CLIENT	CRIPPLE CREEK & VICTOR GOLD MINING COMPANY		
PROJECT	SQUAW GULCH VLF		
TITLE	LOW VOLUME SOLUTION COLLECTION SYSTEM DETAILS SHEET 1 OF 2		
DESIGNED BY	JNM	CHECKED BY	JNM
DRAWN BY	DS	APPROVED BY	KFM
FILENAME	1125GP43	DRAWING No.	A420
		REV	2

LOW VOLUME SOLUTION COLLECTION
RISER PROFILE

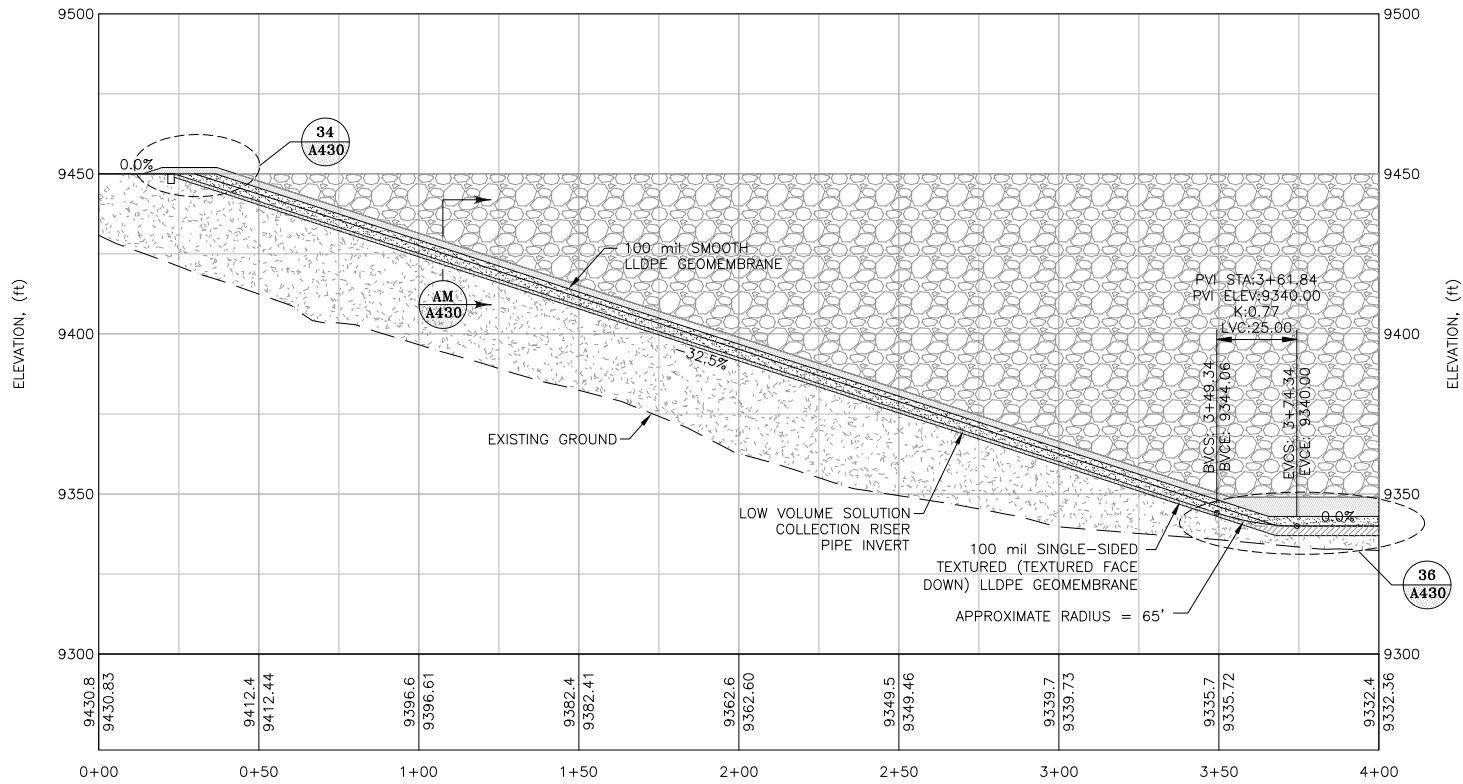
REVISION NOTE:
THE LOW VOLUME SOLUTION COLLECTION SYSTEM WAS RELOCATED, AS A RESULT, THIS ENTIRE DRAWING WAS REVISED AND RE-ISSUED AS REVISION NUMBER 2.

2	02/13/14	RELOCATE PIPE TRENCH / RE-ISSUED FOR CONSTRUCTION	MEN PBS
1	08/15/13	REV. PSSA RISER SUMP / RE-ISSUED FOR CONSTRUCTION	MEN PBS
0	01/07/13	ISSUED FOR CONSTRUCTION	JNM CMT
